Recall Information Bulletin

No: C10134 **Issued:** 2/5/2025

Safety Recall C10134 – Rear Leaf Springs

FECZT (FE140), FEC7T (FE160)

Area 1 (center section of leaf spring)

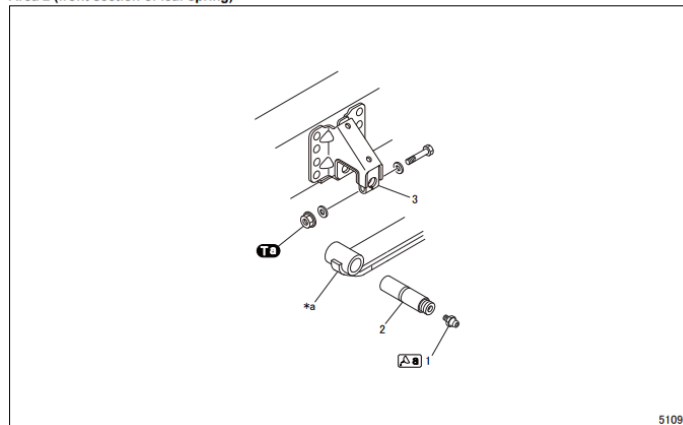
2. Install the rear leaf spring assemblies using instructions found Group 34 of the FUSO FE Gas Service Manual.

Mark	Parts to be tightened	Tightening torque	Remarks
TD	Nut (U-bolt mounting)	340 ± 50 {250 ± 38, 34.6 ± 5.2}	M18
